SALEM GENERATING STATION UNIT NO. 1
ANALYSIS OF DEGRADED GRID VOLTAGE CONDITION
DOCKET NO. 50-272, LICENSE NO. DPR-70

ENCLOSURE NO. 1
SALEM NUCLEAR GENERATING STATION, UNIT NO. 1
RESPONSE TO NRC REQUEST FOR INFORMATION
MILLSTONE ELECTRICAL PROBLEM

FIGURE 1

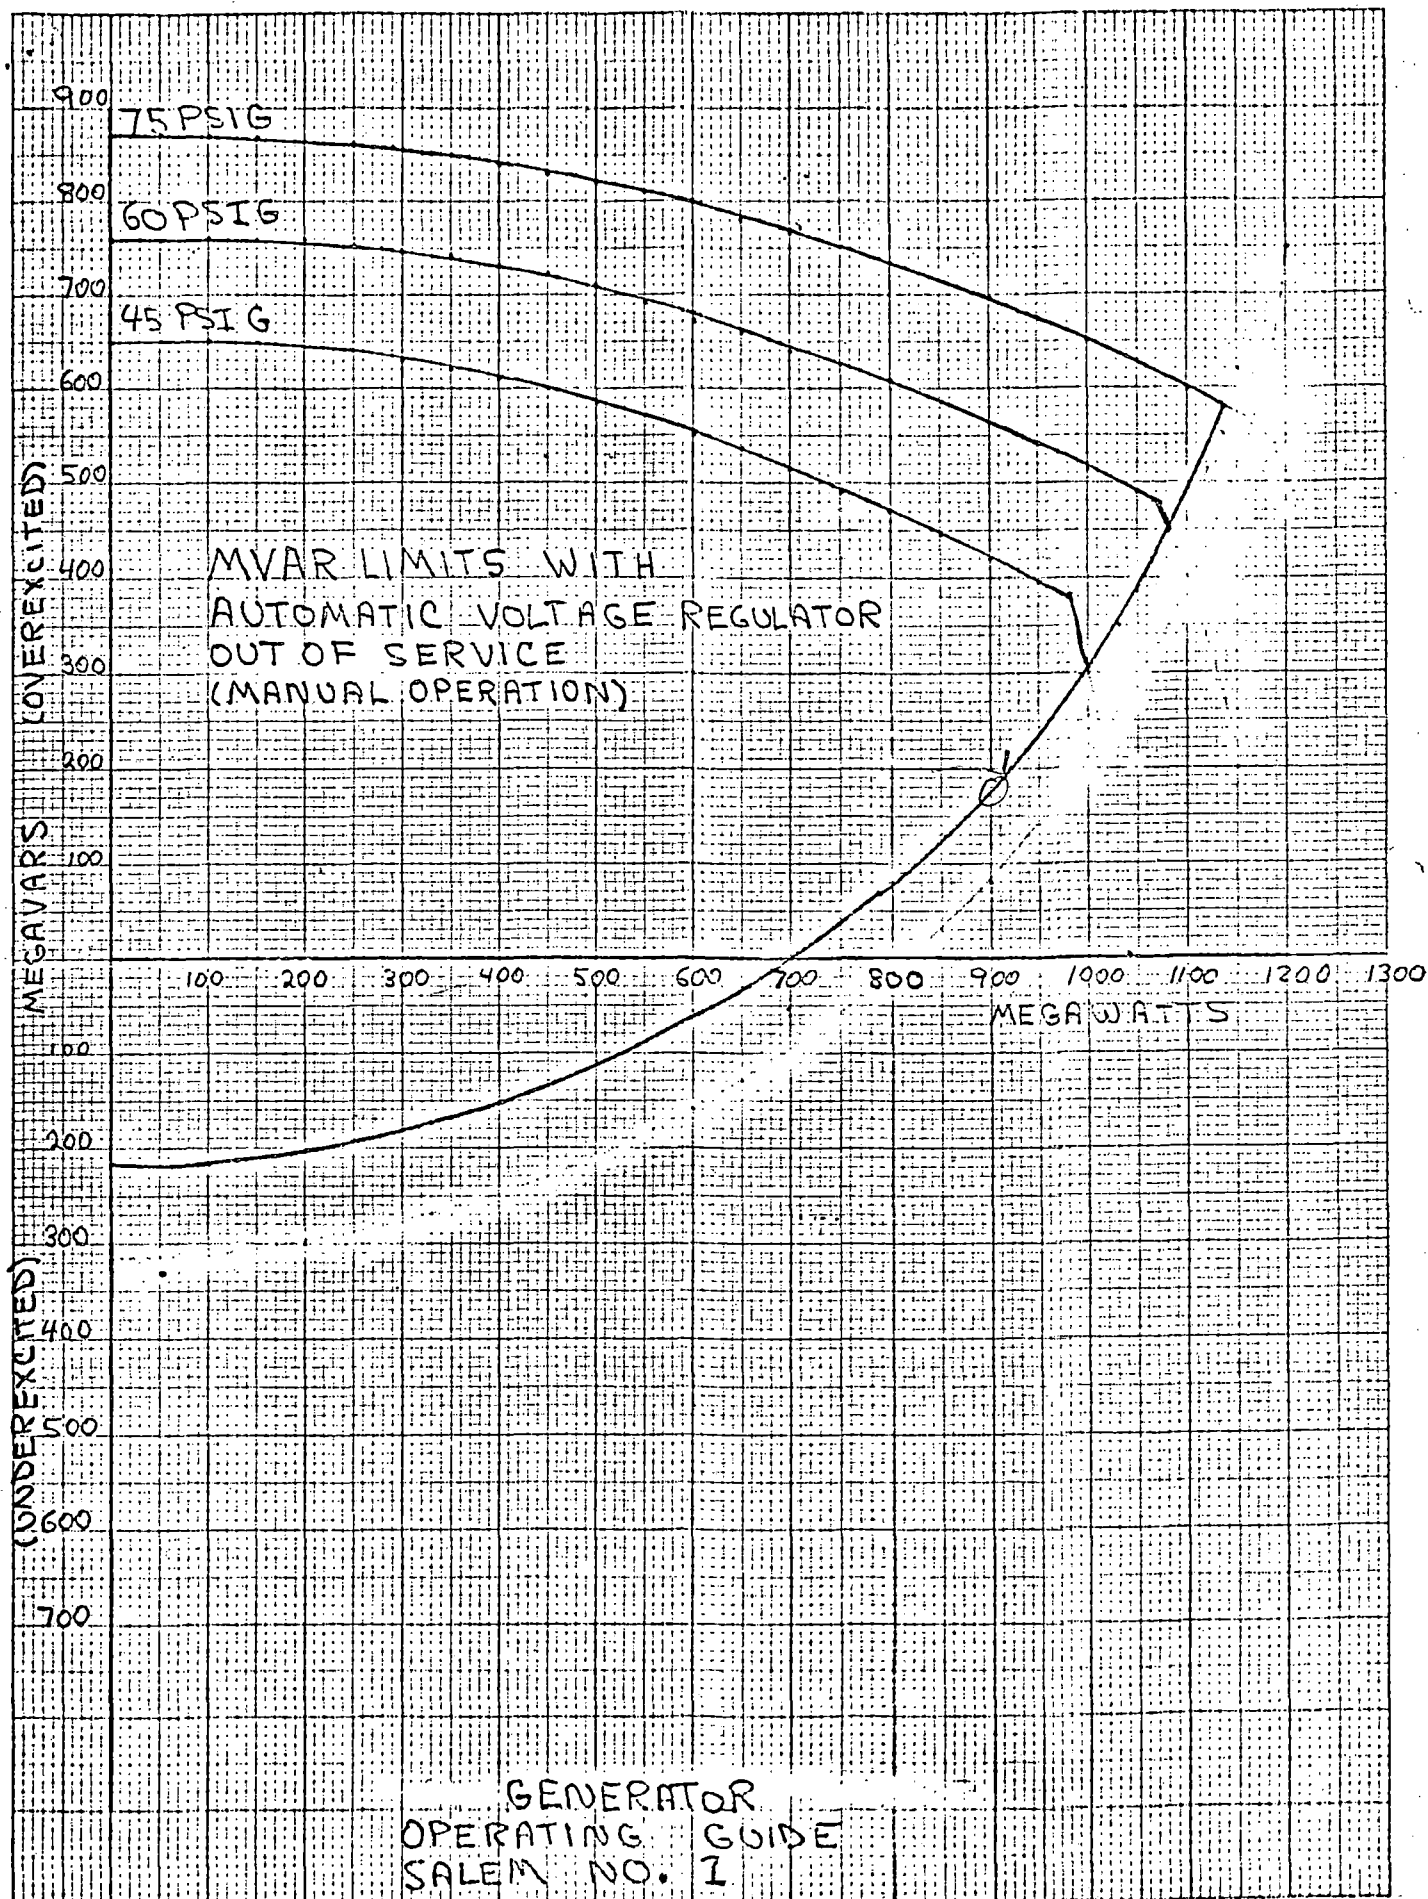
Define the facility operating limits (real and reactive power, voltage, frequency and other) established by the grid stability analyses cited in the FSAR. Describe the operating procedures or other provisions presently in effect for assuring that your facility is being operated within these limits.

Operating instructions currently dictate that generator voltage be maintained between 101 and 105% of rated, that frequency be maintained between 59.75 and 60.25 Hz, and that real and reactive power be maintained within the limits described in Figures 1 and 2. These operating limits are documented in formal operating instructions which are in the hands of both the Station Shift Supervisor and the Electric Dispatcher for their use during operation.
